To: Gerry Bowen
Papio-Missouri River Natural Resources District (PMRNRD)

Date: January 10, 2011

Subject: Preliminary Observations and Recommendations for Repairs to Elkhorn River IPA

Figure 57. Preliminary layout of spur dike field that would restore the river alignment in the vicinity of the Elkhorn Crossing Recreation Area to eliminate the sandbar at the boat ramp.

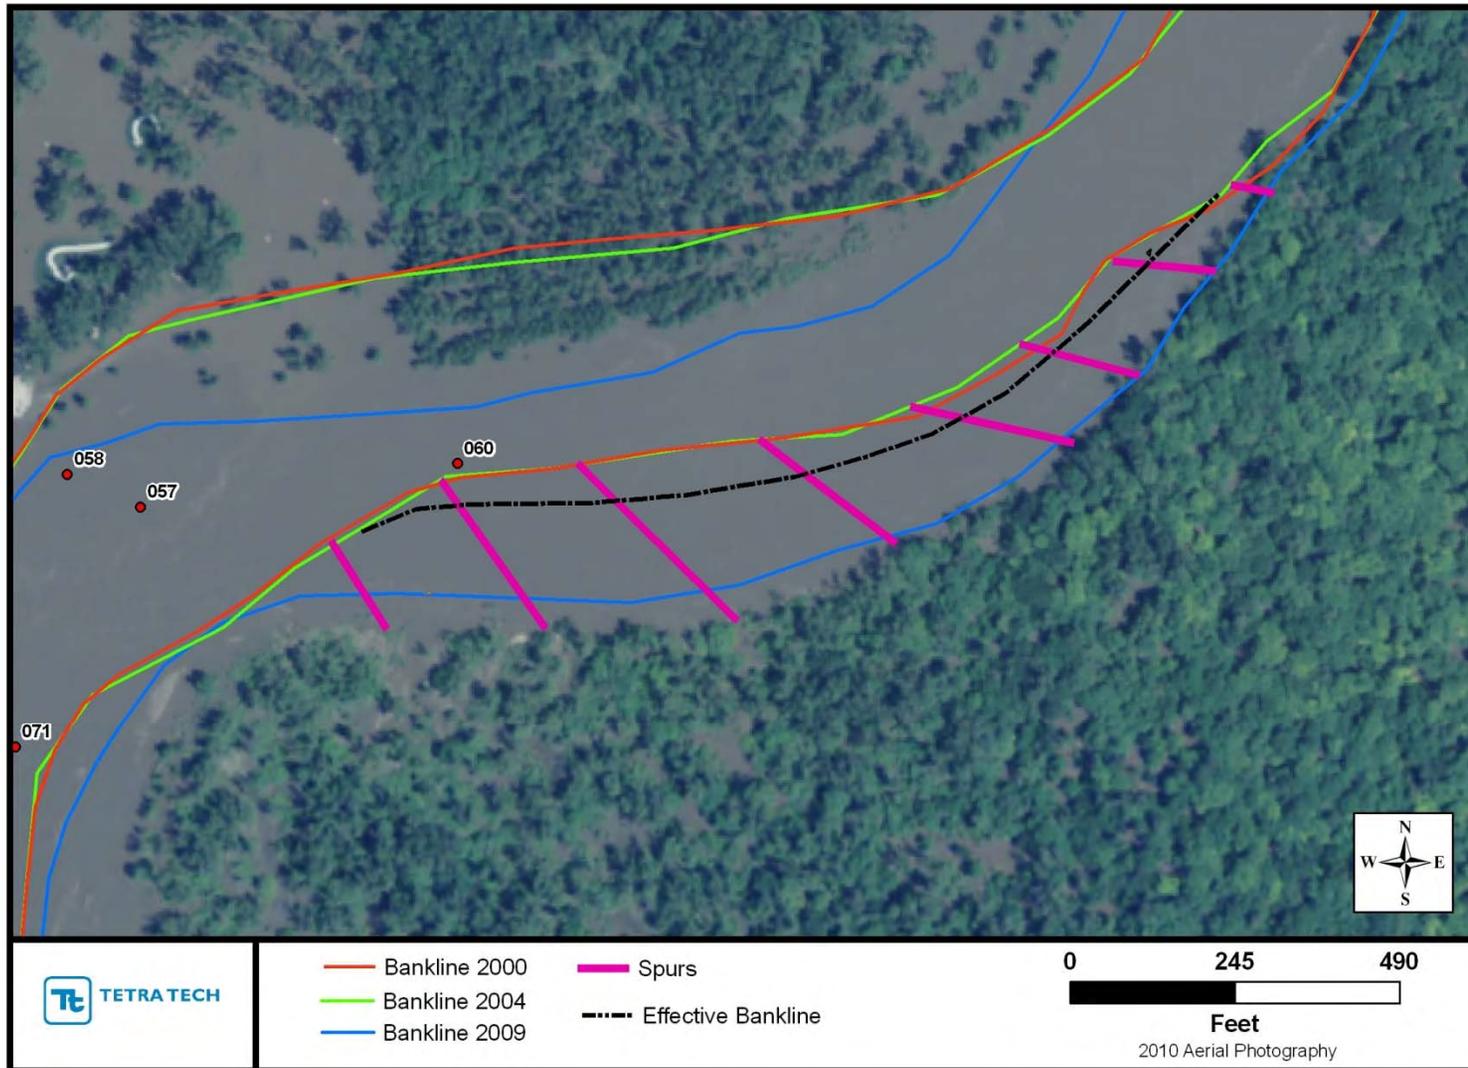
During the field visit, Director Tesar indicated that the rock that is visible in Figure 57 that was placed in 2009 has slumped 2 to 3 feet down into the channel, and he is concerned that the installation may eventually fail. Sufficient data are not available confirm this observation, but it appears to be reasonable based on the existing elevation at the top of the bank compared to the top of the rock. If the observation is correct, it may be necessary to repair the installation to insure continued stability, and these repairs could be done in conjunction with relocating the boat ramp.

Figure 59. Suggested relocation of Elkhorn Crossing Recreation Area boat ramp.

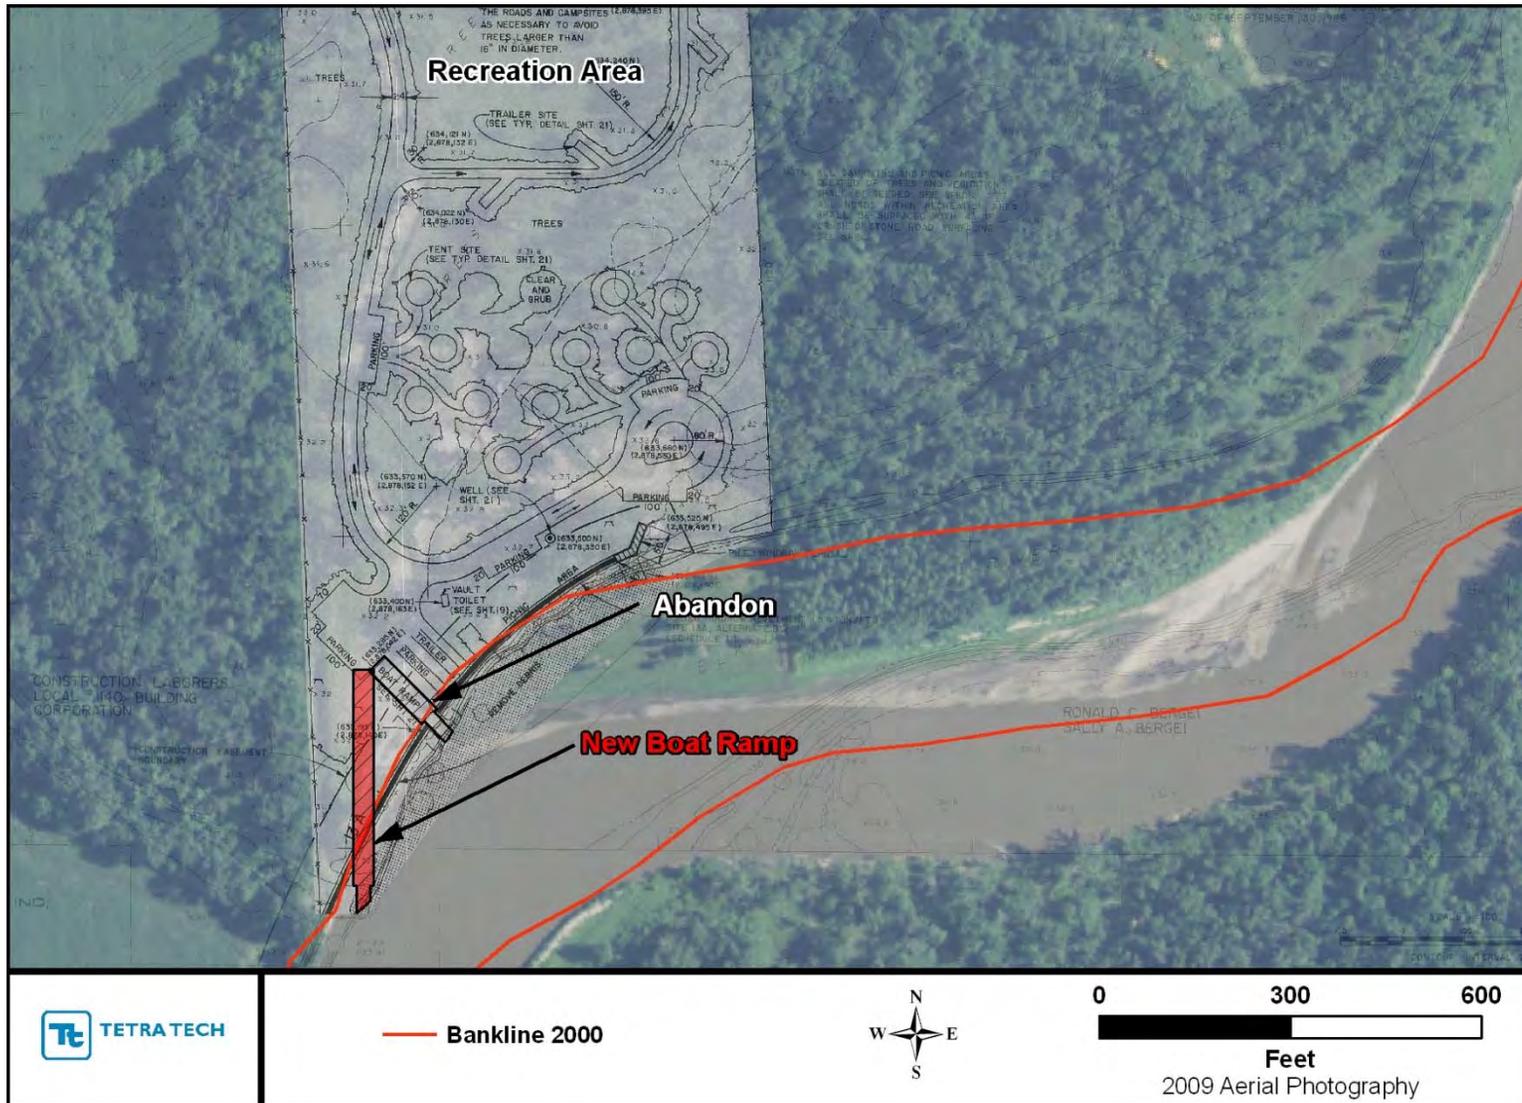
The sandbar at the boat ramp obviously creates a problem for use of the ramp, and PMRNRD has expressed a desire to modify the site in a manner that will remove and prevent future formation of the sandbar. Since this sandbar is formed by accretion on the inside of the bend that is associated with migration of the opposite bank, the only effective way to cause the river to remove the sandbar and insure that it does not re-form is to shift the left bank opposite the site back to its approximate position prior to formation of the sandbar. This could be achieved by constructing a series of rock jetties or bendway weirs in the eroded area along the left bank, with the ends of the structures at approximately the 2004 bankline (**Figure 57**), but the cost would be very high (cumulative length of the spurs would be ~1,700 feet, not considering the necessary tie-back to prevent flanking). It is questionable whether the necessary environmental permits could be obtained for such a project. Two other alternatives could be considered for dealing with the sedimentation issues at the boat ramp, both of which would require stabilization of the existing bankline at IPA Site 14 to insure their continued viability:

1. Periodically dredge an opening to the boat ramp, as necessary, and
2. Re-locate the boat ramp downstream beyond the point of the existing sandbar (**Figure 58**).

Option 1 may not be practical during periods of moderate to high flows that typically occur in the late-spring and early-summer because the dredged area would most likely rapidly fill-in, requiring dredging on a very frequent basis to insure accessibility of the ramp. Option 2 may be the most effective approach if the erosion on the opposite bank is checked and the sandbar does not continue to grow in the downstream direction. Based on the Recreation Area Boundary shown on the second figure that accompanied the July 14, 2010 memorandum from Mr. Winkler, Director of PMRNRD to Mr. Chick, State Conservationist with the Natural Resources Conservation Service (NRCS) that was provided to Tetra Tech as part of the background material, there appears to be room to move the boat ramp downstream and remain within the Recreation Area boundary (**Figure 59**). Based on the preliminary alignment shown in Figure 58, the boat ramp would be roughly twice the length of the existing ramp. With additional site information, it may be possible to extend the parking area to the southwest, shortening the required length of the boat ramp.

Figure 66. Preliminary recommended for bank protection at Field Site 13.

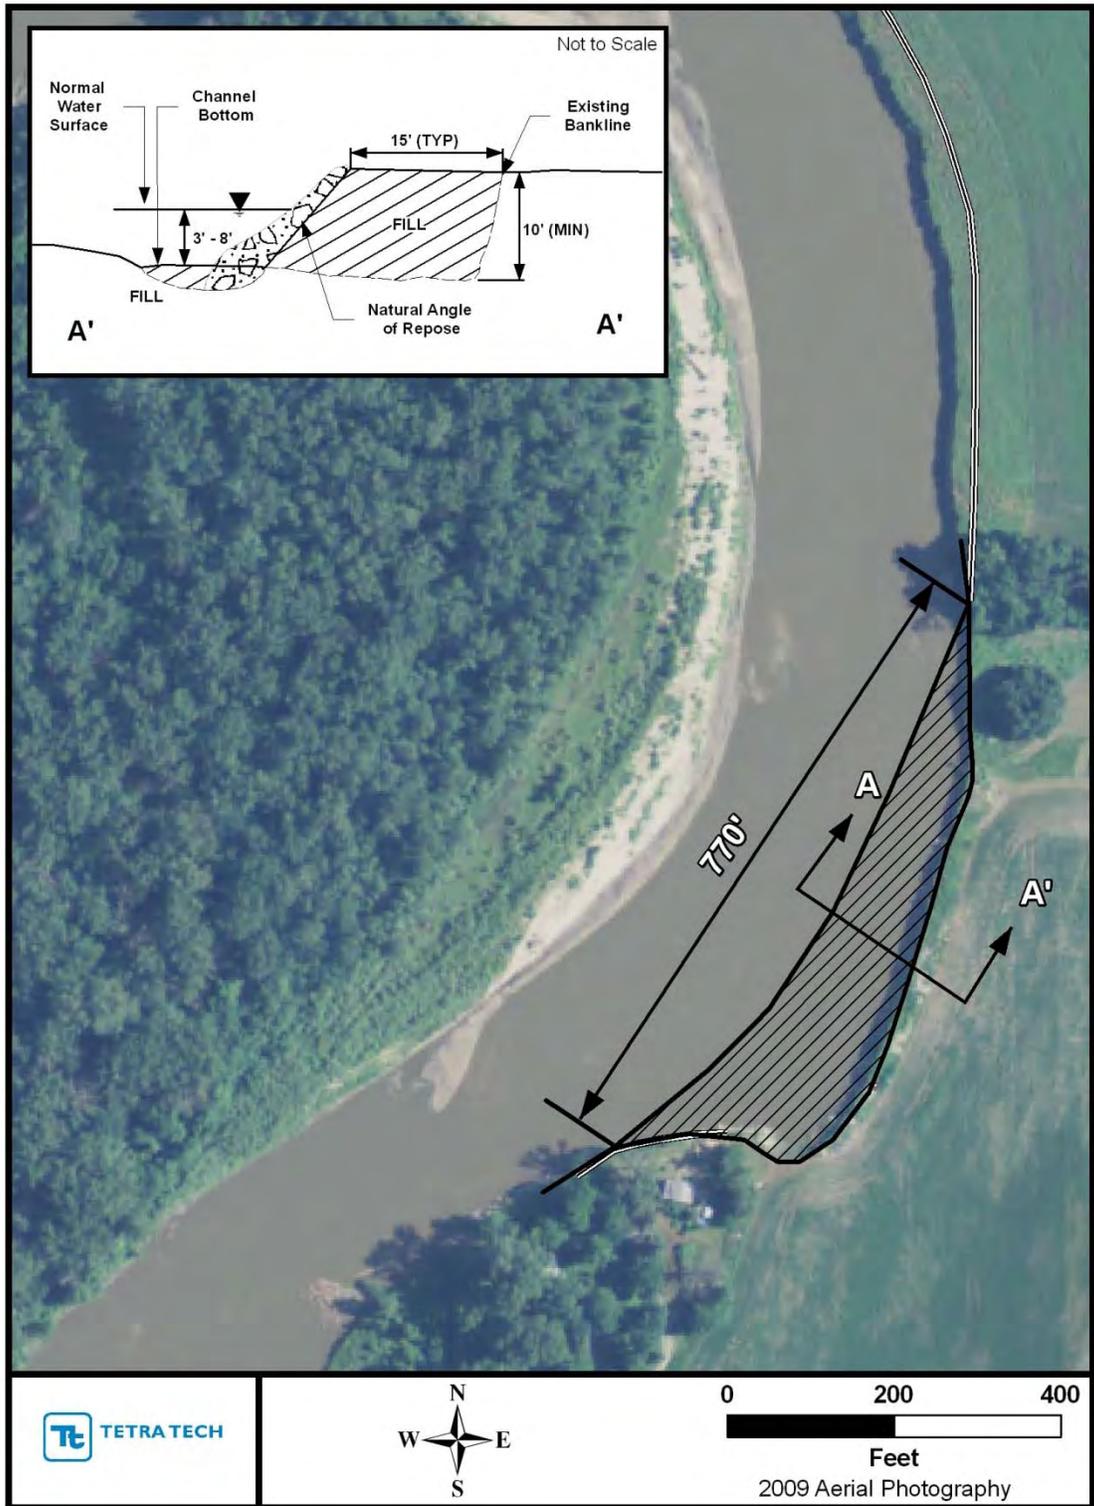
This site, which is located outside the boundaries of the IPA, consists of the bend located about one-half-mile upstream from Highway 36 that has migrated to the east by about 300 feet to the east since October 2000 (**Figure 63**). During the site visit, Director Tesar indicated that there is concern that this bend will continue to migrate, causing the river to flank into the left (east) overbank, potentially abandoning the Highway 36 Bridge. This site was considered in the evaluation to assess whether future changes at the site could potentially affect the stability of the downstream river within the IPA boundaries.

An abandoned meander channel is clearly visible in both the 2009 and 2010 aerial photographs that extends from just upstream from the apex of this bend downstream to just above Highway 36 where it reconnects to the river (**Figures 63 and 64**). Bank protection in the form of rock and concrete rubble has been placed on the bank to protect the properties in the left overbank at the upstream end of the wooded area at the downstream end of the bend (**Figure 65**). The protection has effectively prevented additional erosion of the bankline at this location, but the bankline just upstream has continued to erode. At the present time, there is a relatively sharp hook in the bankline where it transitions from the eroding zone to the protected zone. Although the erodible portion of the bank does not appear to have migrated significantly during the portion of the 2010 high flow before June 16, when the aerial photo was taken, it likely will continue to

erode during future high flows. Considering the relative stability and existing bank protection along the downstream wooded area, it is unlikely that the bend will avulse to the east and impact Highway 36 or the bridge crossing. Considering the geometry of the bend, the most likely scenario is that, as the bend continues to develop, the radius of curvature will decrease sufficiently to encourage the bend to cut off on the inside, effectively straightening the river upstream from the bend. Continued development of the bend will, however, cause additional erosion in the adjacent field, and could endanger the homes that are located in the wooded area (many, or perhaps most, of which were damaged by flooding during the 2010 high flows).

To prevent continued erosion of this bend, the erodible bankline should be restored to its approximate position in 2004 and protected over a distance of about 750 feet in the downstream portion of the bend, and piled windrow revetment should be placed on the top of the bank along the remainder of the erodible portion of the bend (~1,500 feet). The 2004 bankline can be restored by either backfilling the eroded area and placing rock along the new bankline, or by constructing a series of rock spurs (**Figure 66**). Based on the amount of rock required for the spurs, it appears that backfilling and protecting the new bankline would be the most economical method to restore the 2004 bankline in the downstream 750 feet of the site. Although sufficient topographic data are not available to accurately estimate the appropriate application rate for the piled windrow revetment, it is assumed for purposes of estimating the probable cost that the rate would be in the range of 3.0 tons/ft, similar to many of the downstream sites within the IPA.
